TO:	Emily Wentworth, Town of Hingham	DATE:	March 30, 2016
FROM:	Joe SanClemente, P.E., AICP	HSH PROJECT NO.:	2015151.01
SUBJECT:	Avalon Hingham Shipyard II – 319 Lincoln Street Vanasse Traffic Peer Review – Response to Comments

Howard Stein Hudson (HSH) has prepared this memorandum in response to the comments received on the Avalon Hingham Shipyard II Project from the Town's peer review consultant, Vanasse & Associates, Inc. (VAI) in a memorandum dated March 10, 2016. Since that time the Proponent has reduced the scope of the Project to include just 190 residential units (60 fewer units) and associated adjustments to the site plan. HSH has prepared a technical memorandum documenting the change to the Proposed Project, the reduced traffic impacts, and the proposed mitigation.

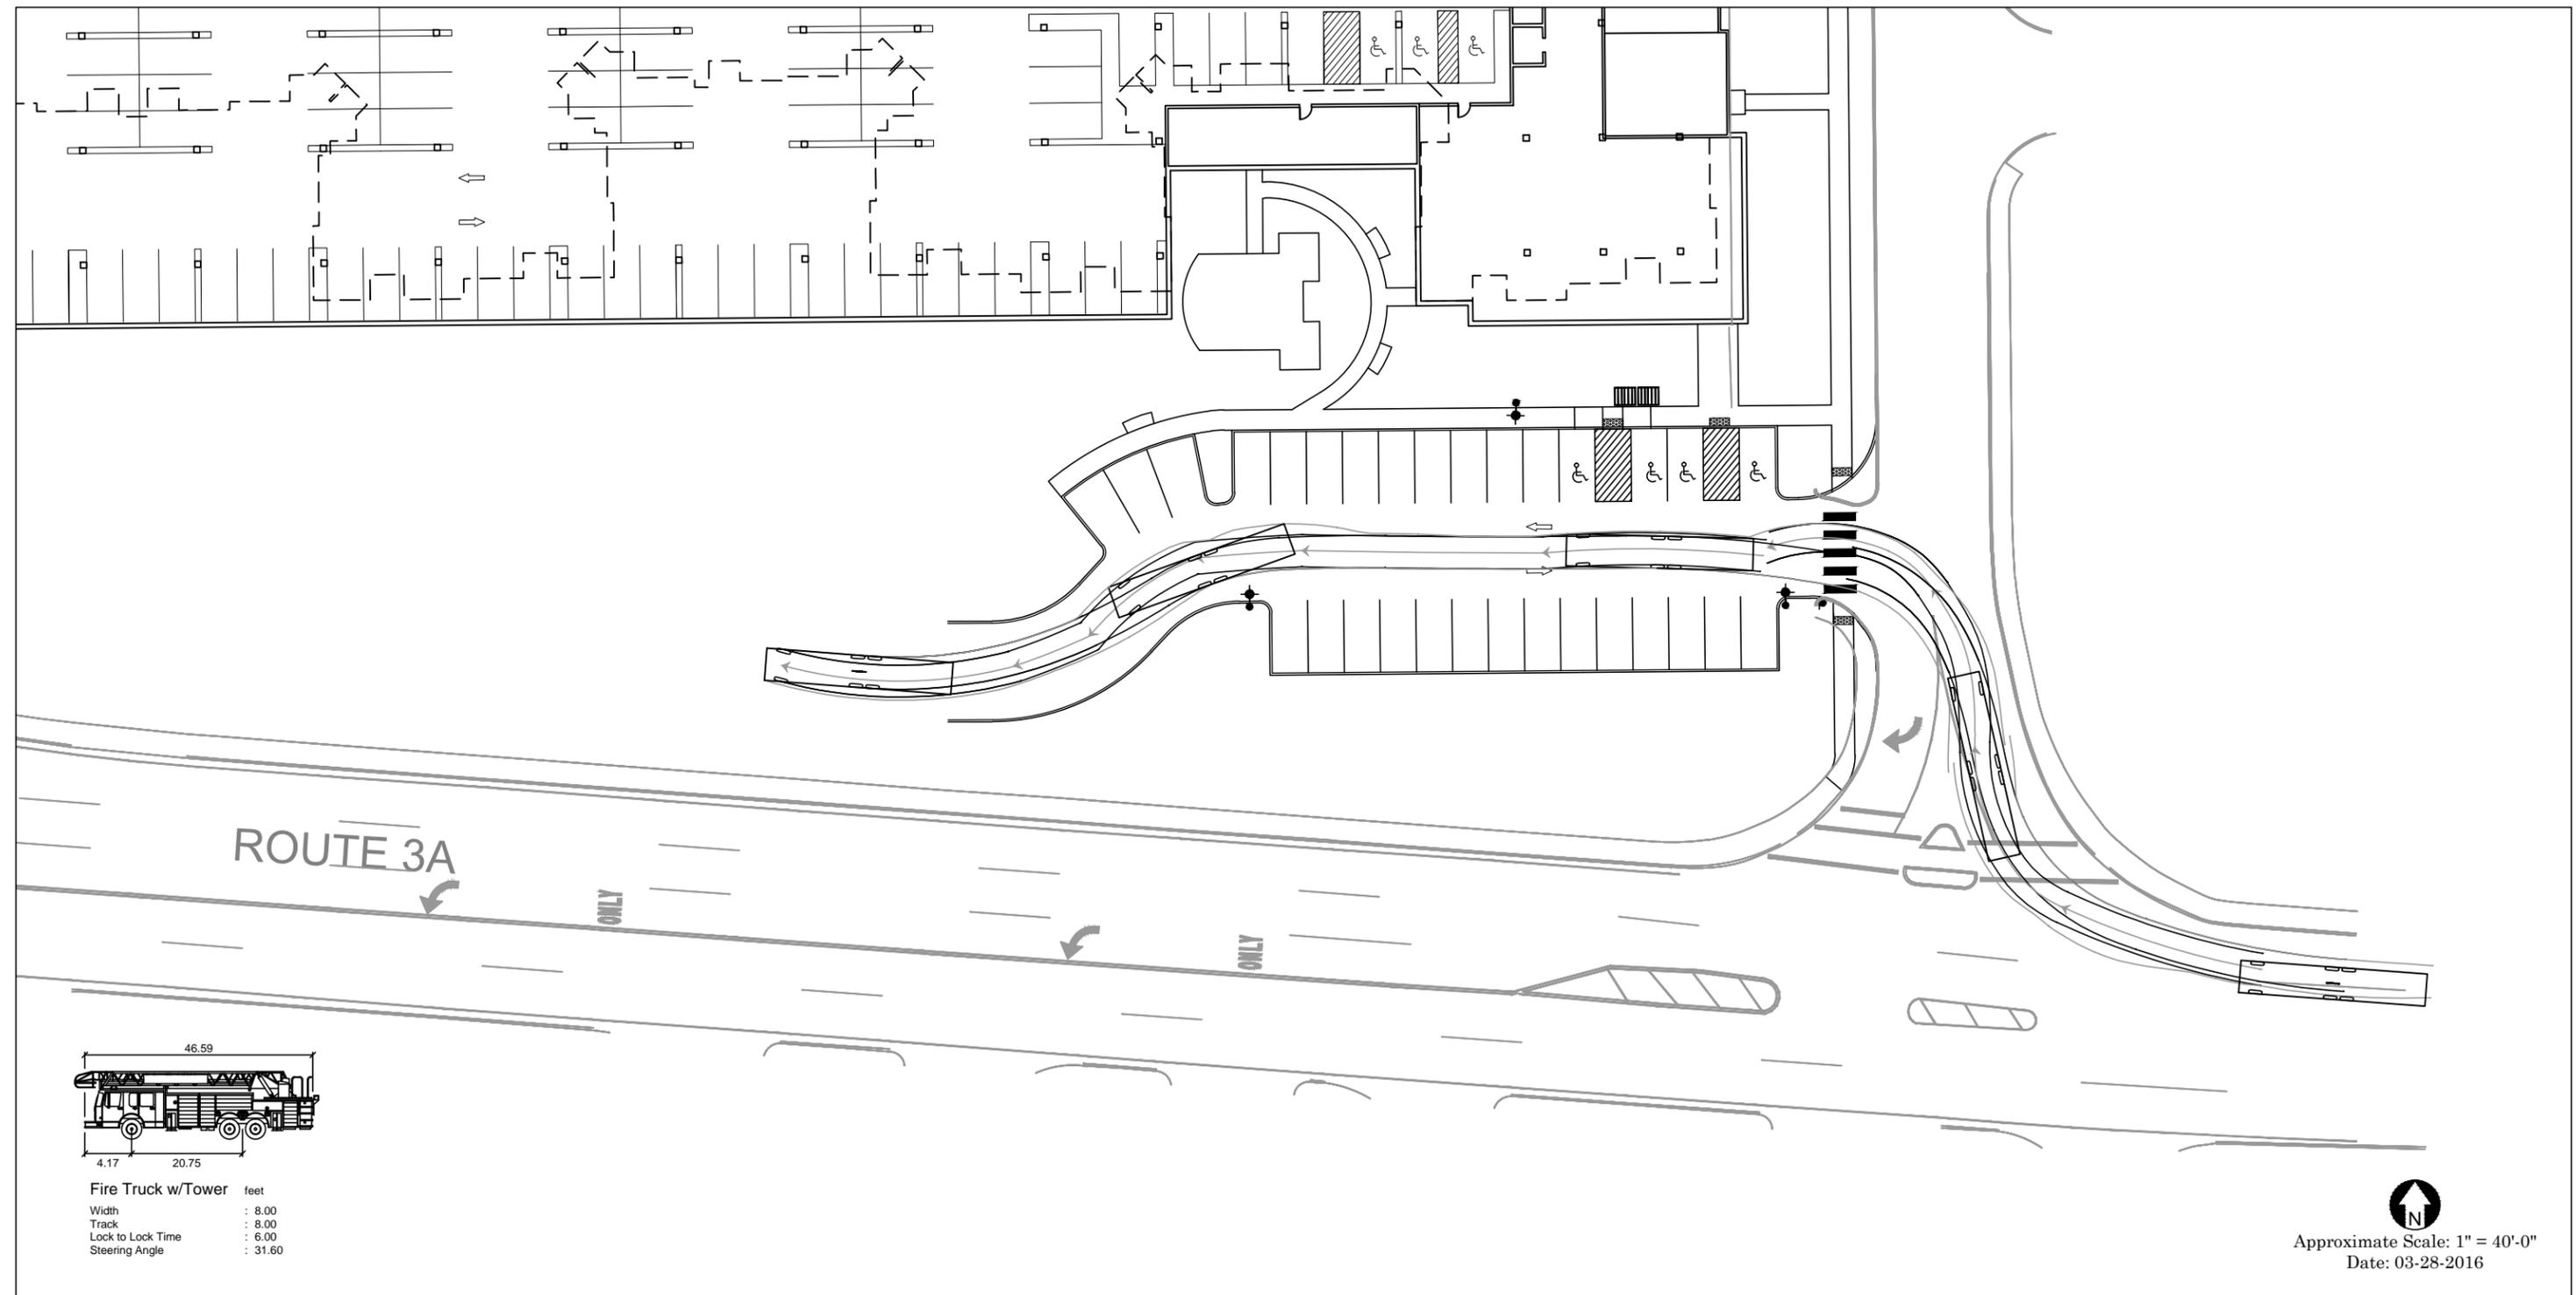
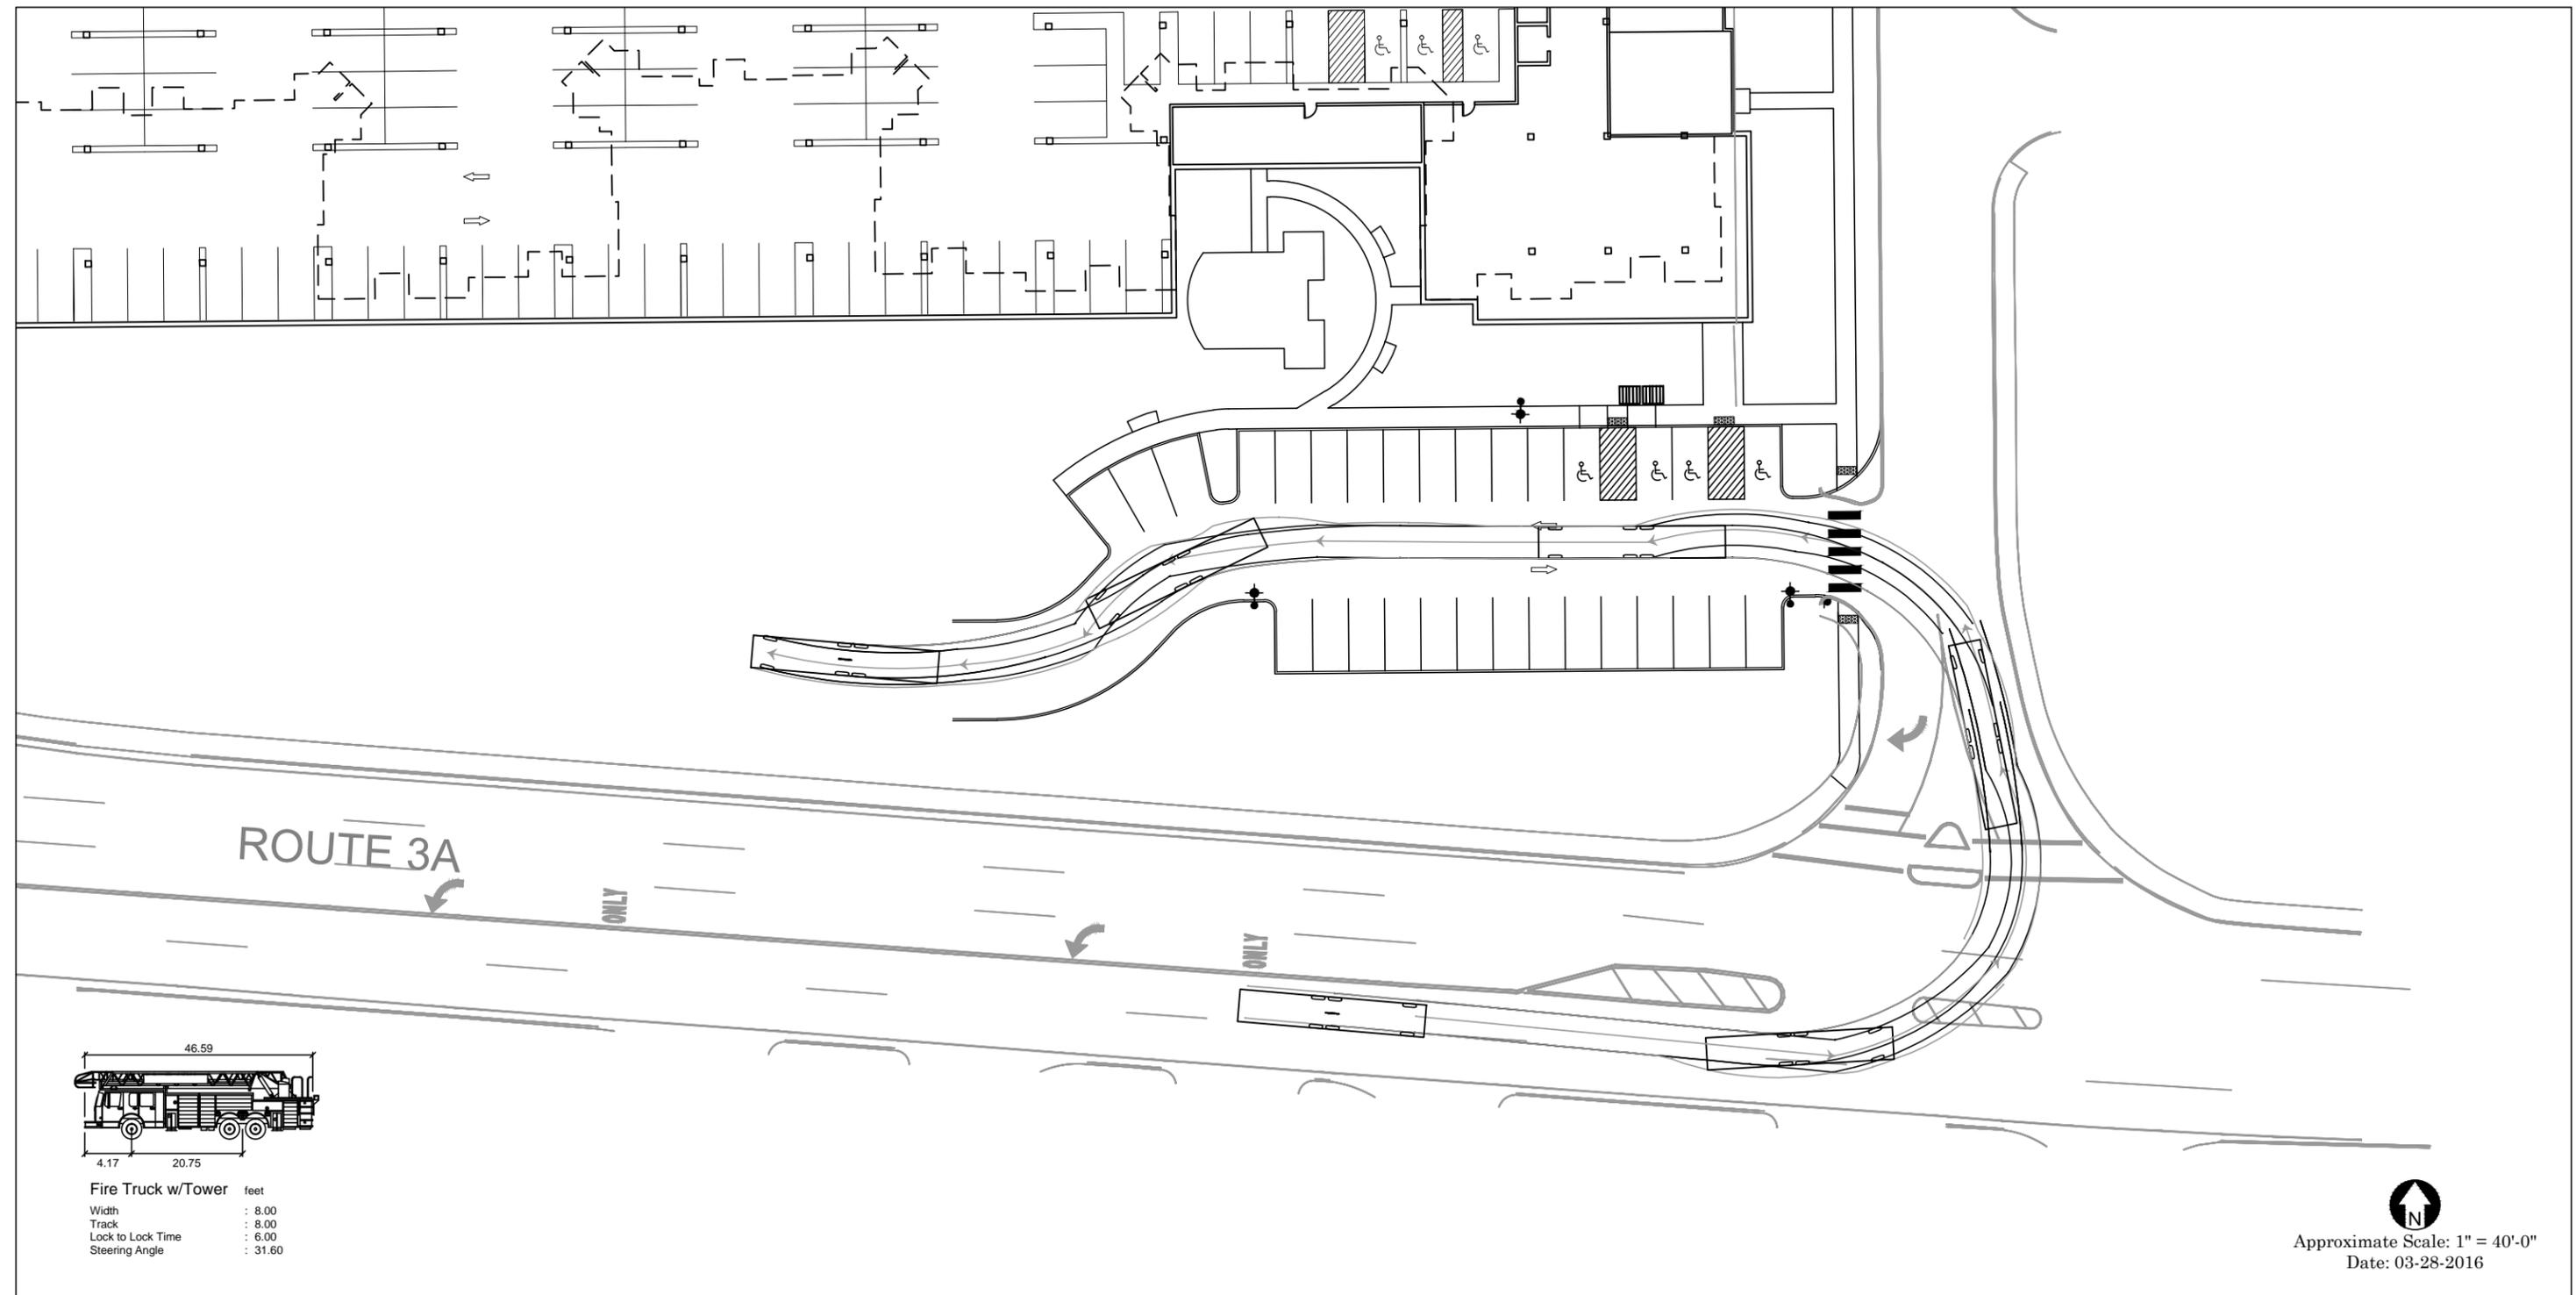
**Comment 1:** The Applicant's engineer provided a truck turning analysis for the Town of Hingham Fire Department design vehicle (tower truck) and an intermediate size tractor semi-trailer combination (WB-50). The turning analysis demonstrated that the subject vehicles can access and circulate within the Project site in an unimpeded manner; however, we note that the fire truck would need to back-up to exit the visitor parking area. The Applicant's engineer should also provide a turning analysis for an SU-30/40 (small delivery/moving vehicle and trash/recycling vehicle) that demonstrates that the subject vehicle can access and stage in the loading areas without blocking the garage access points. In addition, the analysis should also demonstrate the location and maneuvering required to serve the trash/recycling area.

Response 1: See attached truck turning analysis.
